Regarding: 03V-309 Expansion of Recall
1999 through 2001 Model Year Yamaha XV1600
Transmission Factory Modification Campaign

Technical BULLETIN

RECALL

1999~2001 XV16 MODELS FACTORY MODIFICATION CAMPAIGN

Main Shaft Modification:

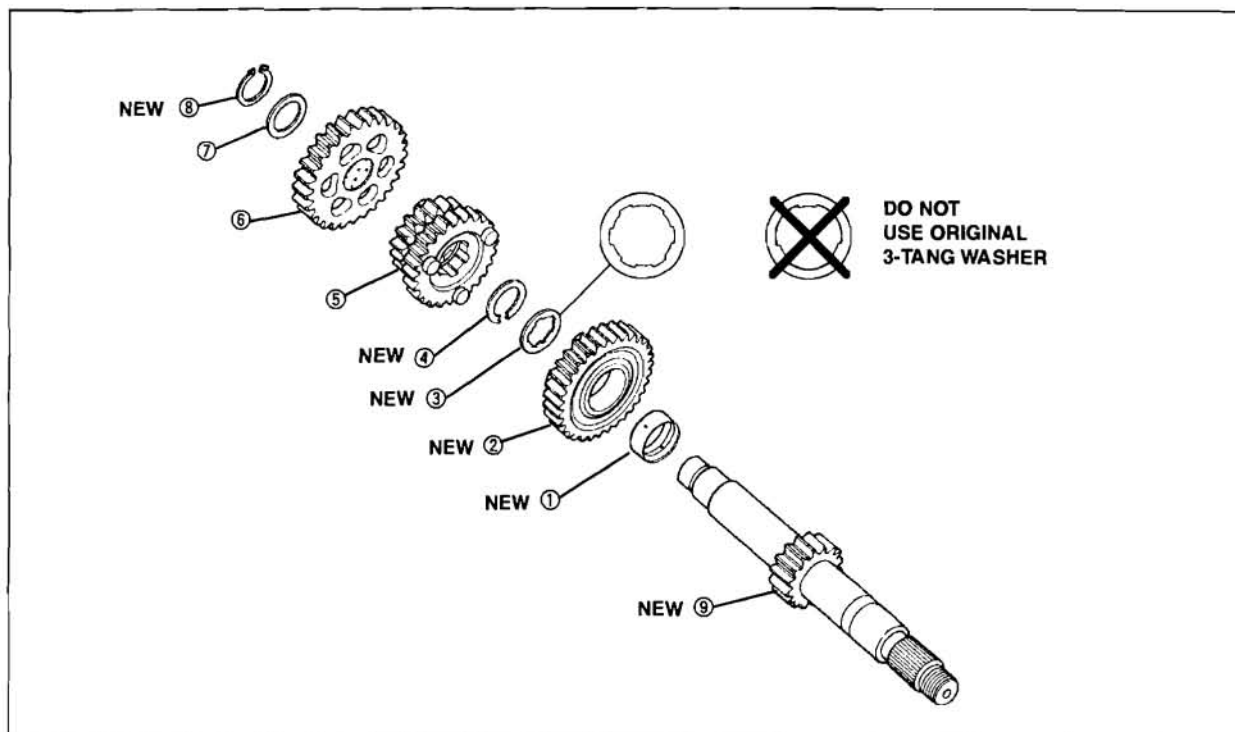
- Completely disassemble the main shaft. The Washer ⑦, 5th Pinion Gear ⑥, and 2nd/3rd Pinion Gear ⑤ will be reused.
- Install the components on the new-type Main Shaft ⑨ in the following order. Lubricate all components with engine oil. Be sure circlips are installed with the sharp edge of the inner diameter facing away from the mating washer.

- ① Collar – NEW
- ② 4th Pinion Gear – NEW
- ③ Washer – NEW
- ④ Circlip – NEW
- ⑤ 2nd/3rd Pinion Gear – Reuse original part
- ⑥ 5th Pinion Gear – Reuse original part
- ⑦ Washer – Reuse original part
- ⑧ Circlip – NEW

Be sure to use all of the new parts in the kit. Otherwise, the transmission can still fail. Be sure that you are installing the new washer ③. It is thicker than the original and can be easily identified by its six tangs on the inner diameter instead of the three on the original washer.

Drive Shaft Modification:

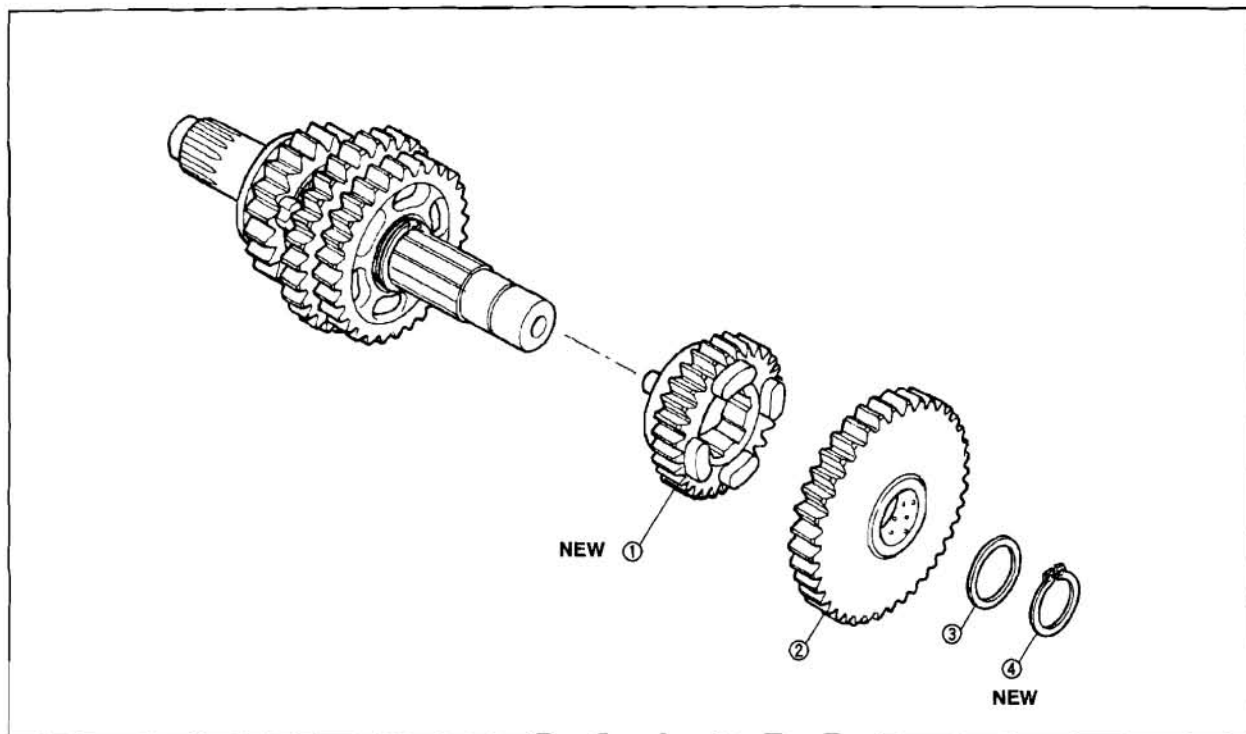
- Remove the circlip and washer from the Drive Shaft, then remove the 1st Wheel Gear and the 4th Wheel Gear. Do not disassemble the rest of the components on the shaft.
- Install the components on the original Drive Shaft in the following order. Lubricate all components with engine oil. Be sure the circlip is installed with the sharp edge of the inner diameter facing away from the mating washer.

- ① 4th Wheel Gear – NEW
- ② 1st Wheel Gear – Reuse original part
- ③ Washer – Reuse original part
- ④ Circlip – NEW

Be sure to use all of the new parts in the kit. Otherwise, the transmission can still fail.
